EXHIBIT 3 - STAFF REPORT

DATE: August 17, 2023
TO: Planning Commission Members
FROM: Tom Schauer, Senior Planner
SUBJECT: Public Hearing – Planned Development Amendment PDA 2-23, Three Mile Lane Review TML 1-23, and Landscape Plan Review L 25-23

PRELIMINARY SITE
LIGHTING PLAN

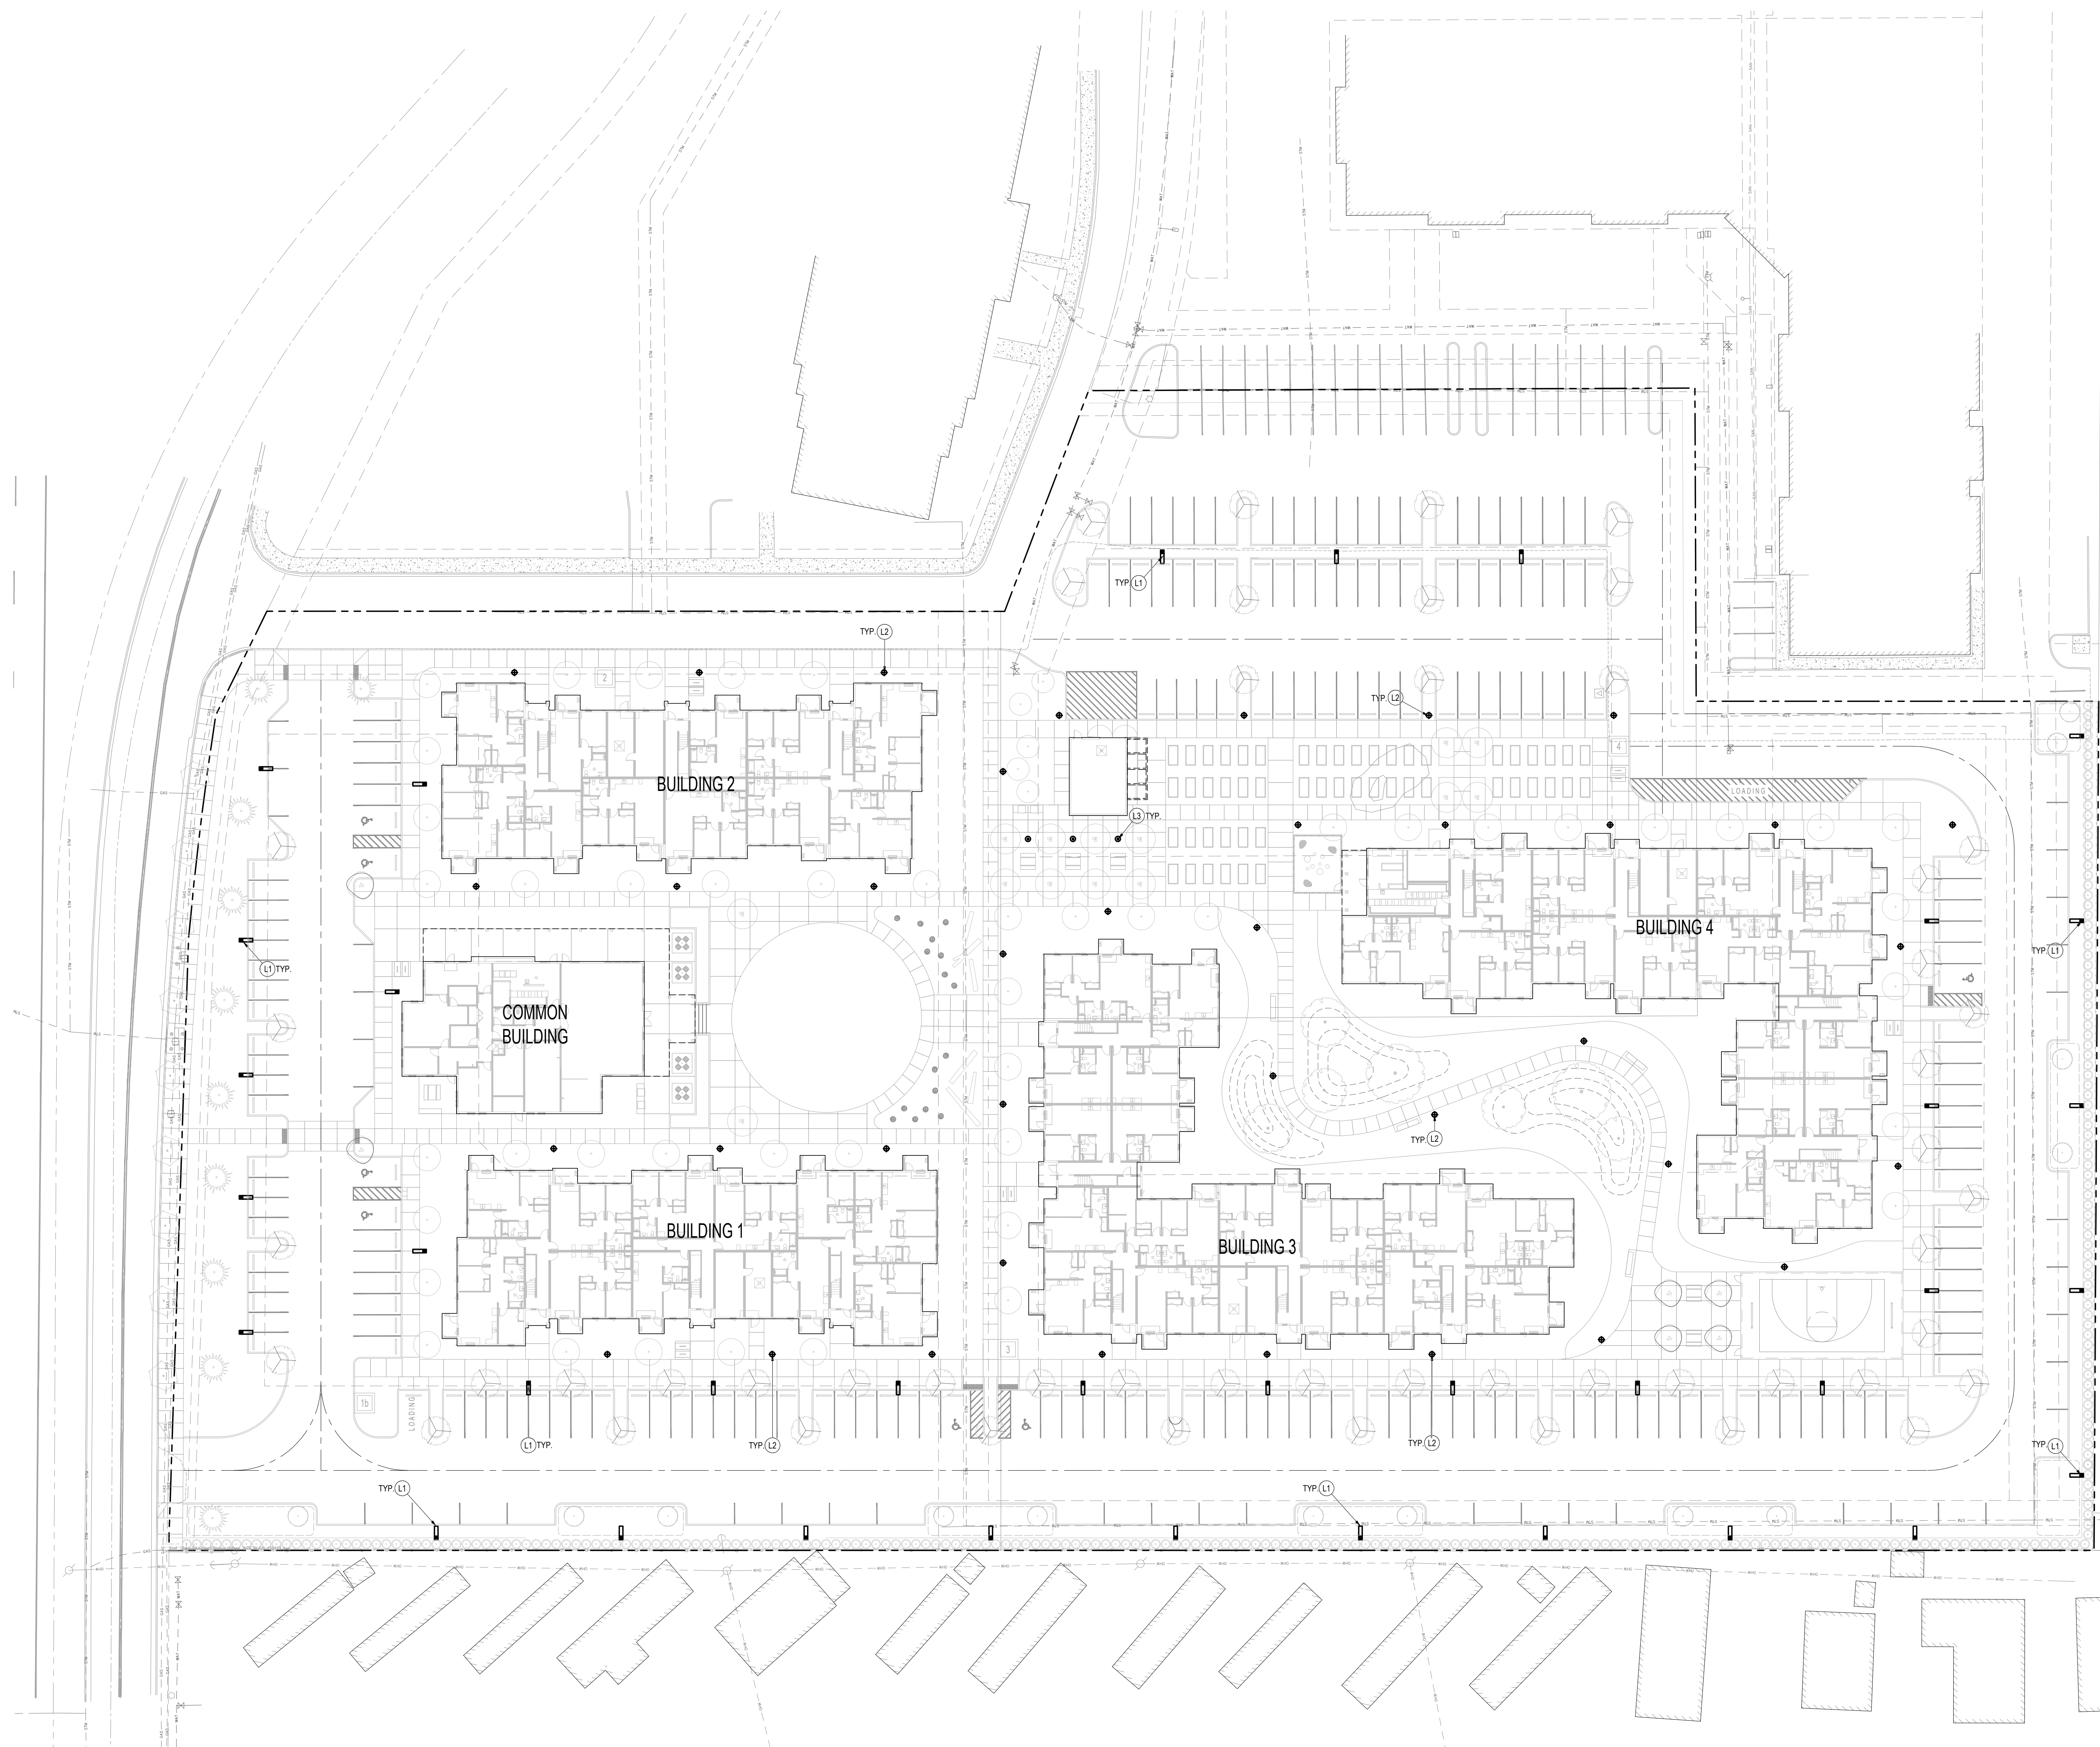
FINDING: SATISFIED WITH CONDITIONS. Sheet L1.01 provides the lighting legend below. As a condition of approval, prior to issuance of the building permits, the applicant shall provide documentation indicating the type of cut-off, downcast shielding or characteristics associated with the lighting, including the 18'-20' L1 light poles around the perimeter of the parking area near residential uses. In addition, the applicant shall provide documentation regarding the shielding and downcast directional nature of any wall-mounted lighting, such that it won't directed outward toward streets or residential areas.
